Access Compliance Report

Public Rights-of-Way (Curb Ramps)

Intersection ID: 23991	Main Street: MONTIBELLO_DR	Cross Street: RIVER_RIDGE_RD	Location: SW
ADA ID: 6909F6529090	Ramp Type: PerpDiag	Initial Pass/Fail: Fail	Overall Compliance: No
Severity Score: 12.5			
Codes/Mitigation Info/Possible Solution		Field Measurements/Component Compliance

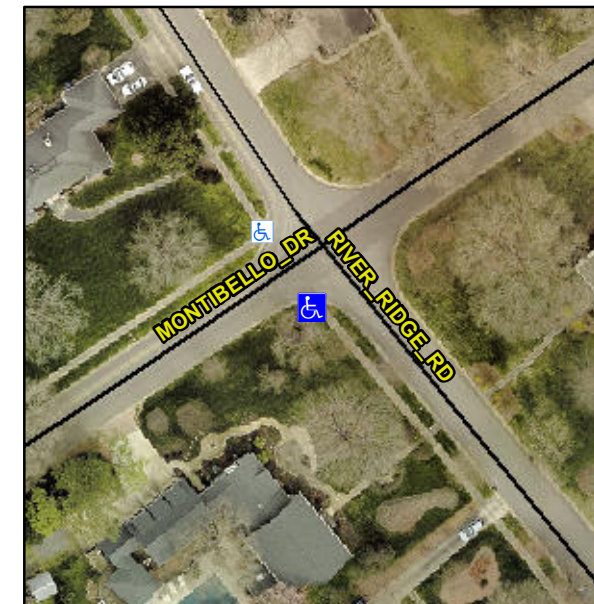
Not Found, R304.2.2

Compliance	Description	Data	Compliance	Description	Data
N/A	Ramp Length (in)	33.0	No	Ramp Slope (%)	9.6
Yes	Ramp Width (in)	48.0	Yes	Ramp XSlope (%)	0.6
N/A	Flare Type LT	N/A	N/A	Flare Type RT	N/A
N/A	Flare Slope LT (%)	N/A	N/A	Flare Slope RT (%)	N/A
N/A	Flare Traversable LT?	N/A	N/A	Flare Traversable RT?	N/A
N/A	Landing Length (in)	N/A	N/A	DWS Provided?	N/A
N/A	Landing Width (in)	N/A	N/A	DWS Contrast?	N/A
N/A	Landing Slope (%)	N/A	N/A	DWS Length (in)	N/A
N/A	Landing X Slope (%)	N/A	N/A	DWS Full Width?	N/A
N/A	Landing Curb? (Y/N)	N/A	N/A	DWS Offset (in)	N/A
N/A	Shared Landing?	N/A			
N/A	Gutter Ponding?	N/A	N/A	Gutter Slope (%)	N/A
N/A	Gutter Lip Ht (in)	N/A	N/A	Gutter X Slope (%)	N/A
N/A	Painted X Walk1?	No	N/A	Painted X Walk2?	No
	X Walk 1 Direction	To NE		X Walk 2 Direction	To NW
N/A	X Walk 1 Width (in)	N/A	N/A	X Walk 2 Width (in)	N/A
	X Walk 1 Slope (%)	5.2		X Walk 2 Slope (%)	2.9
	X Walk 1 X Slope (%)	2.6		X Walk 2 X Slope (%)	6.0

N/A	Ramp inside XWalk1?	N/A	N/A	Ramp inside XWalk2?	N/A
	Road Slope (%)	1.5	N/A	Clear Space?	N/A
	Road X Slope (%)	8.2	N/A	Clear Space to XWalk (in)	N/A
N/A	Any Obstructions?	N/A	N/A	Storm Grate/Utility Hazard?	N/A
	Obstruction Type			Storm Grate/Utility Type	
		N/A			N/A
			Yes	Surface Condition? (G/P)	Good

Remove & Replace Curb Ramp With Two New Directional Ramps or Equivalent.
